## PRODUCT/PROCESS CHANGE NOTICE (PCN)

PCN #: <b>TB1504-01 (R1)</b> DATE <b>October 23, 2015</b>	MEANS OF DISTINGUISHING CHANGED DEVICES:
Product Affected: <b>Selective Products shipped in Reel</b> (Refer to Attachment II for affected part#)	<input type="checkbox"/> Product Mark
Date Effective: <b>February 1, 2016 Earliest Date - Refer to specific date by package type</b>	<input type="checkbox"/> Back Mark
	<input type="checkbox"/> Date Code      Refer to PCN effective date by package type in page 4.
	<input checked="" type="checkbox"/> Other

### ATTACHMENT I - PCN #: TB1504-01 (R1)

Figure 1: Additional Label pasted on ESD/Moisture barrier bag and Pizza box

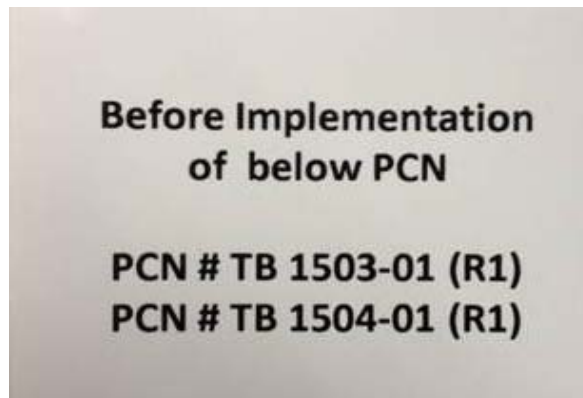
Customers may expect to receive shipments of products in new packing no sooner than 90 days from the date of this PCN notification. Shipments to customers may contain products shipped with either the existing packing or new packing during the transition period. Shipments made in the existing packing after the PCN becomes effective will have an additional label pasted on the ESD/moisture barrier bag and pizza box.
